Docket Number:	15-AFC-02
Project Title:	Mission Rock Energy Center
TN #:	210540-2
Document Title:	Mission Rock Supplement to the AFC
Description:	Minor revisions to the Air Quality, Public Health, and Biological Resources Analyses
Filer:	Cenne Jackson
Organization:	California Energy Commission
Submitter Role:	Commission Staff
Submission Date:	2/26/2016 12:01:29 PM
Docketed Date:	2/26/2016

APPLICATION FOR CERTIFICATION SUPPLEMENT

Mission Rock Energy Center

2015-AFC-2

Figure 2.1-1R1.
General Arrangement
Mission Rock Energy Center

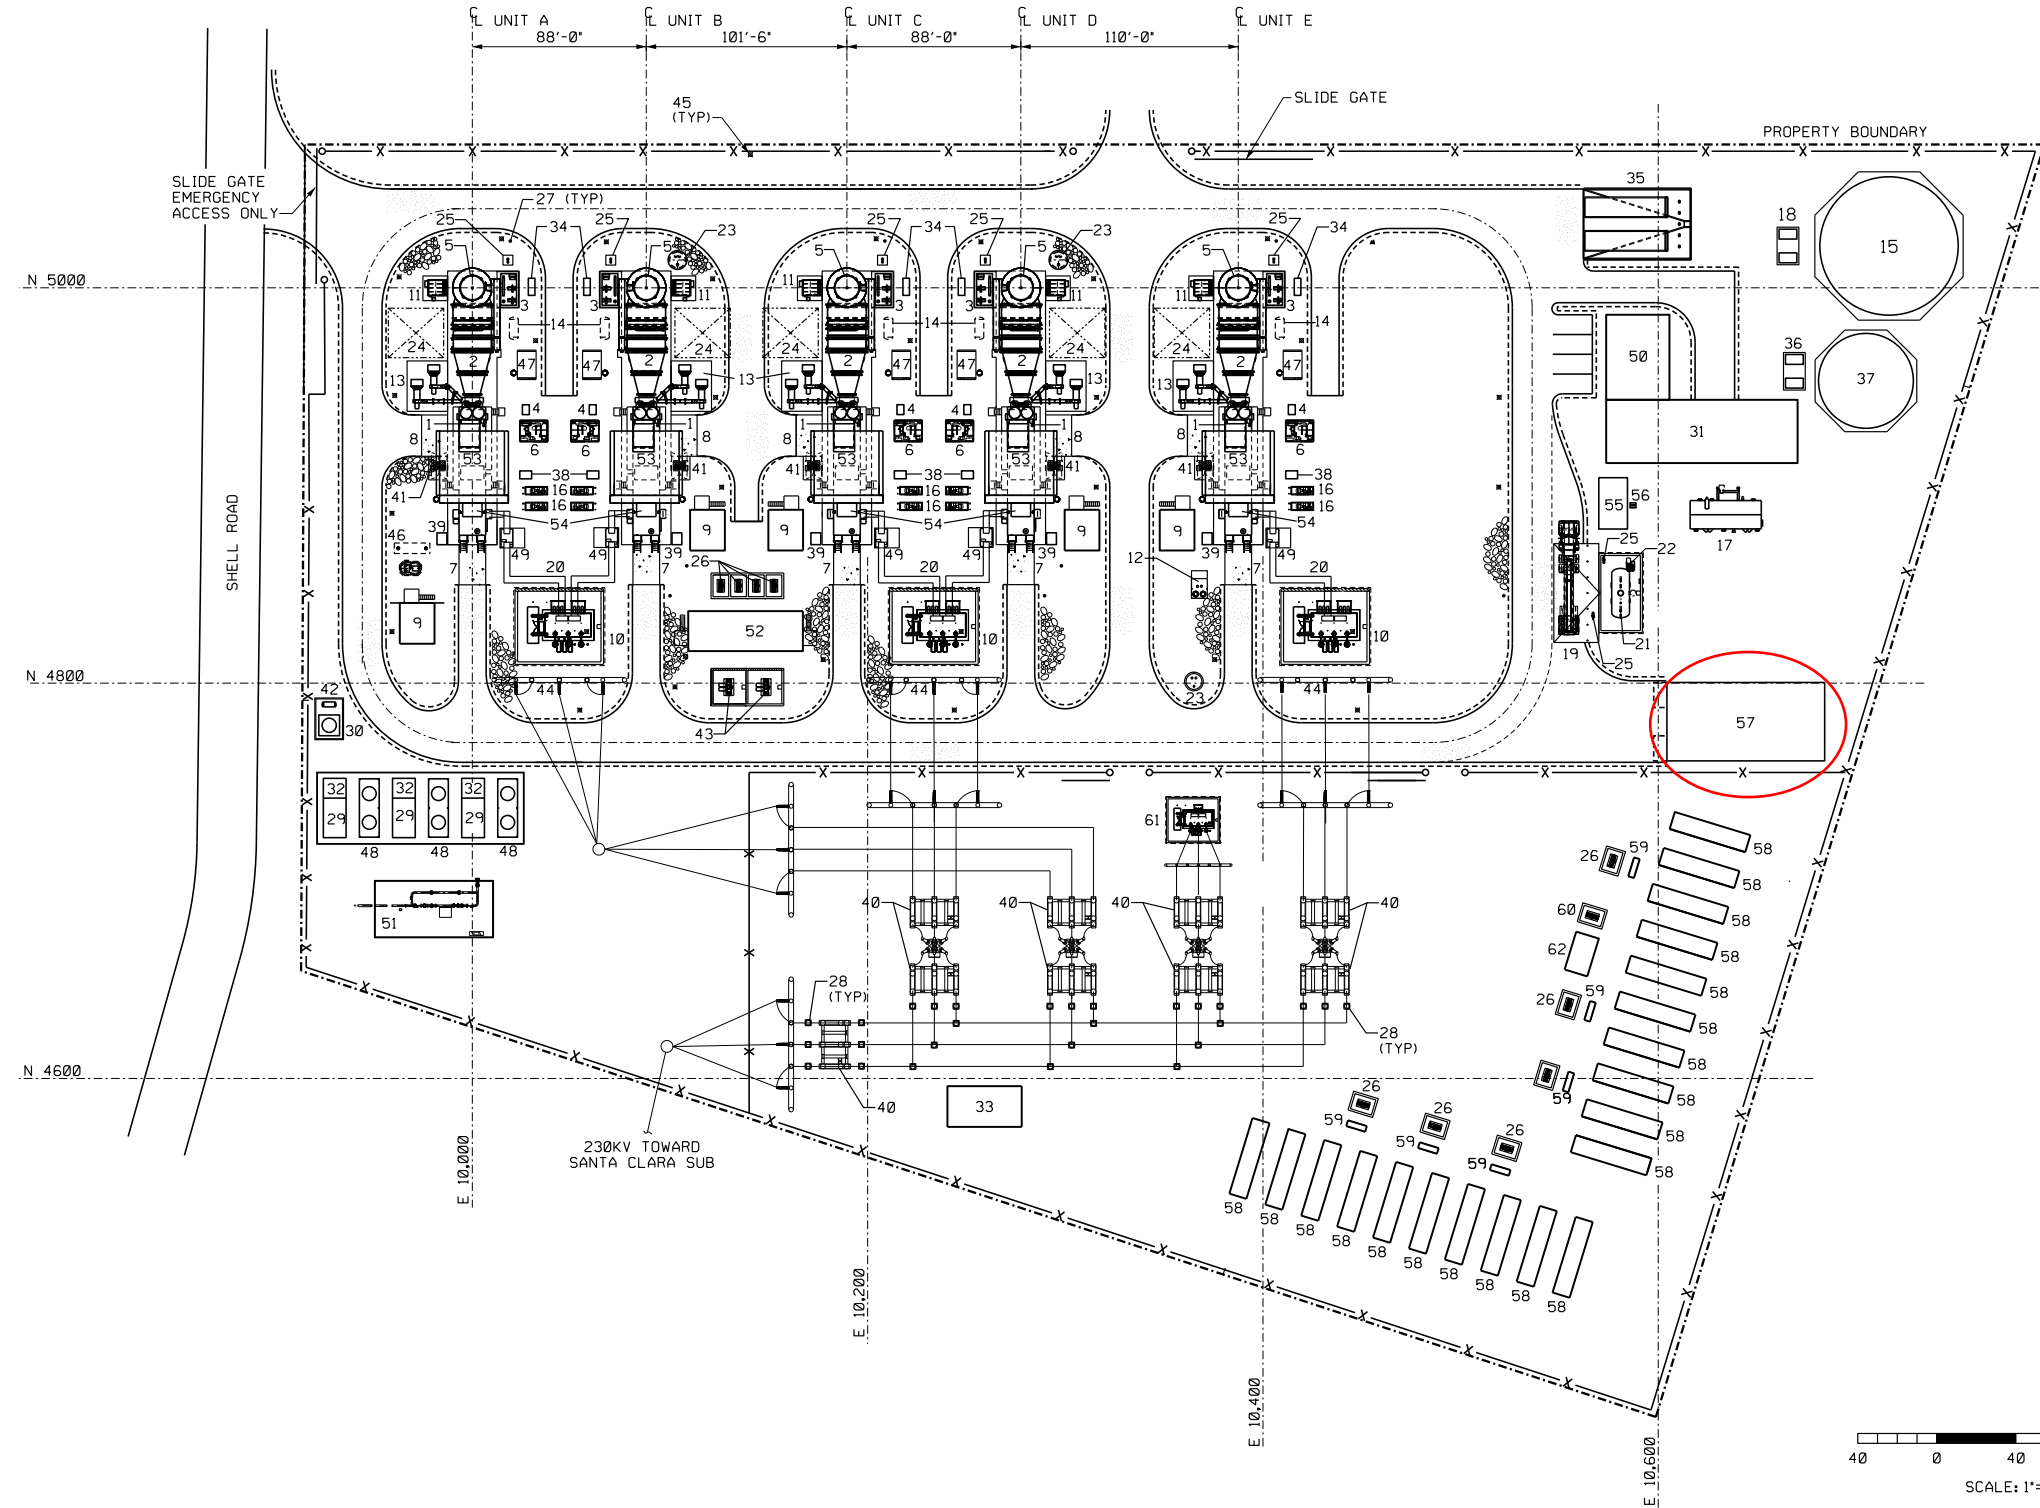
The following figures in Section 2.0, Project Description, are being replaced. The area of the change has been identified by a red circle.

- Figure 2.1-1R1 – General Arrangement (small configuration change)
- Figure 2.1-2R1 – Elevation drawings (showing the fans on top of the chillers)

○ Area changed

Figure 2.1-2R1.
Elevations
Mission Rock Energy Center

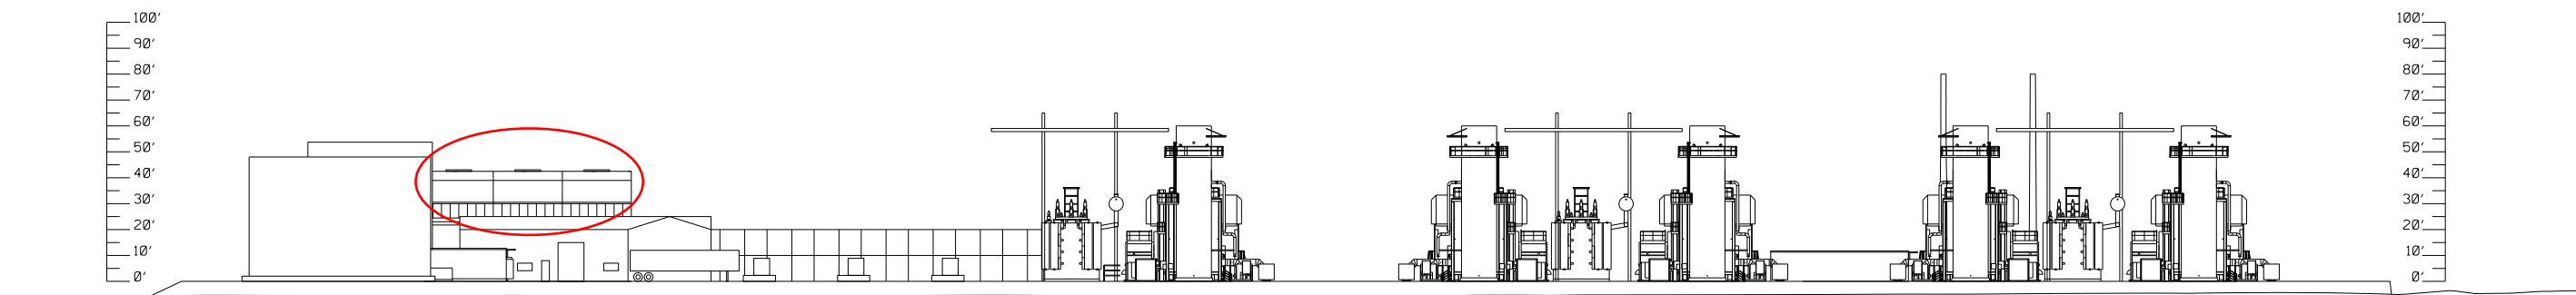
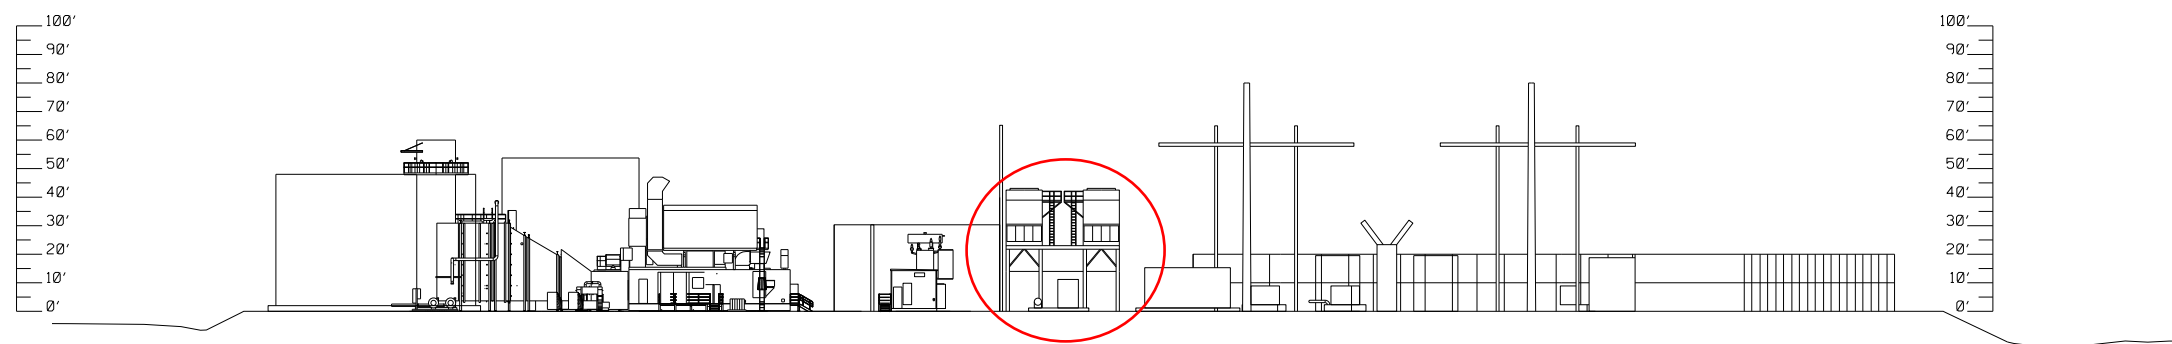
○ Area changed

Figure 5.1B-1R1 Facility BPIP Modeling Plot

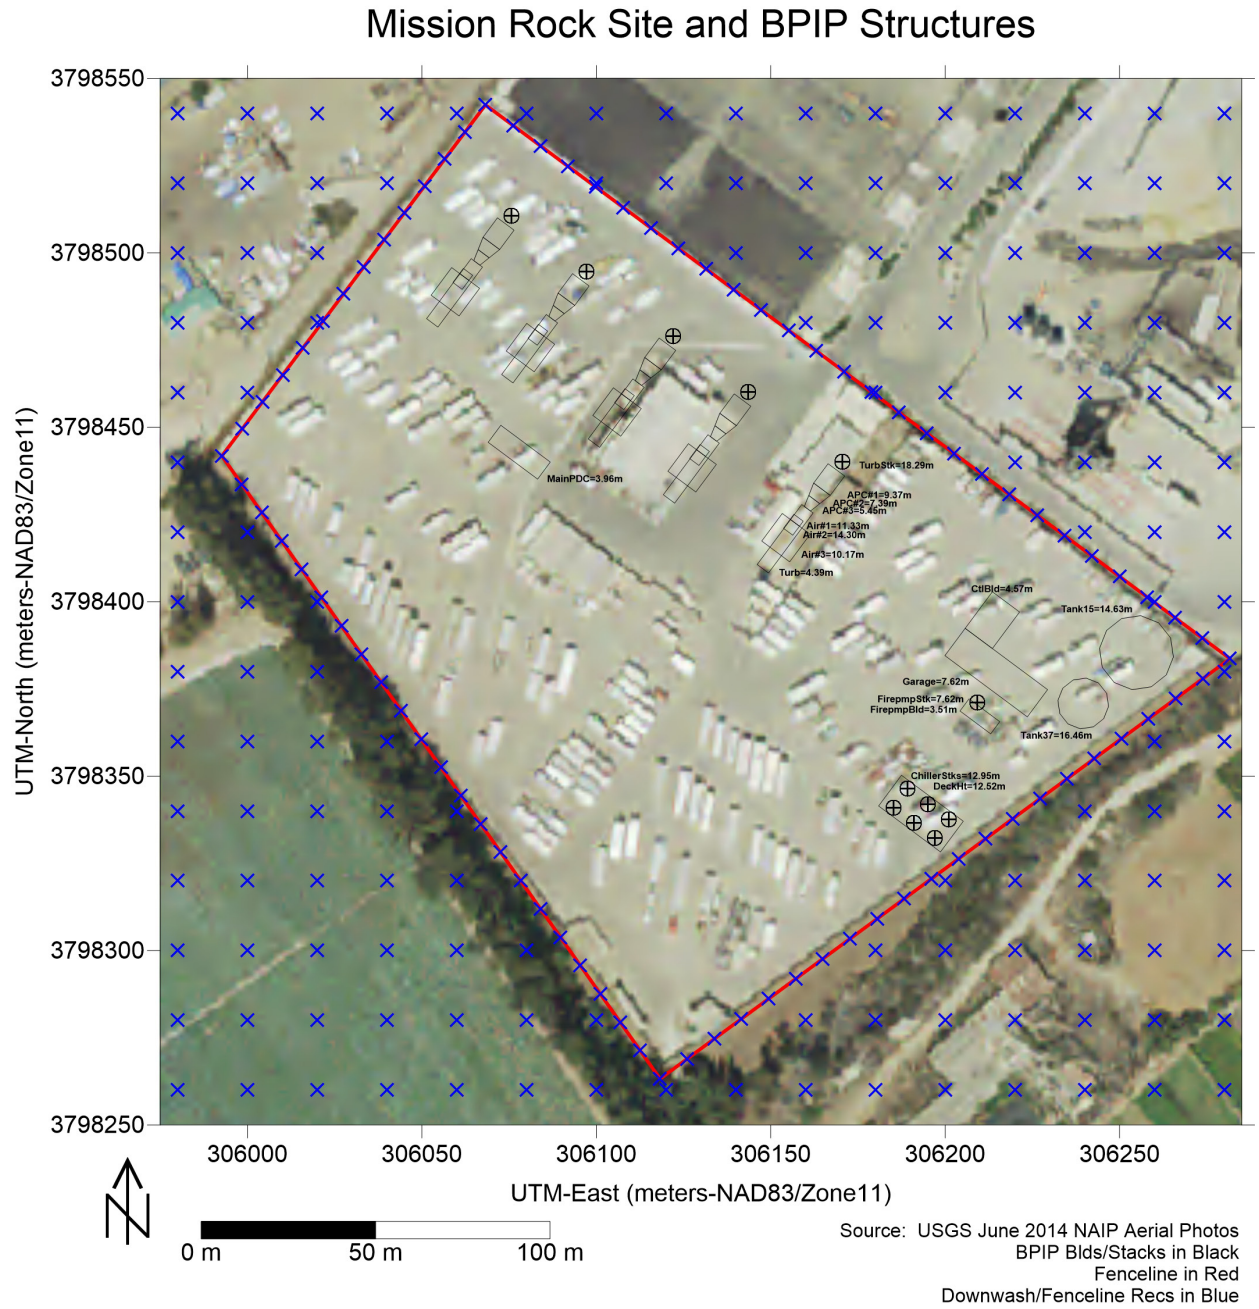
- Replace the Air Quality section in its entirety with the attached text.
- Replace the following Air Quality Appendix 5.1A materials:
 - Appendix 5.1A index page
 - Table 5.1A-8 – Sprint Chiller Package
 - Table 5.1A-9 – Sprint Chiller Package HAPS
 - Attachment 5.1A-3 – Evapco Chiller
 - Attachment 5.1A-3a – TAS Packaged Chiller Plant
- Replace the following Air Quality Appendix 5.1B materials:
 - Appendix 5.1B index page
 - Figure 5.1B-1R1 – Facility BPIP Modeling Plot
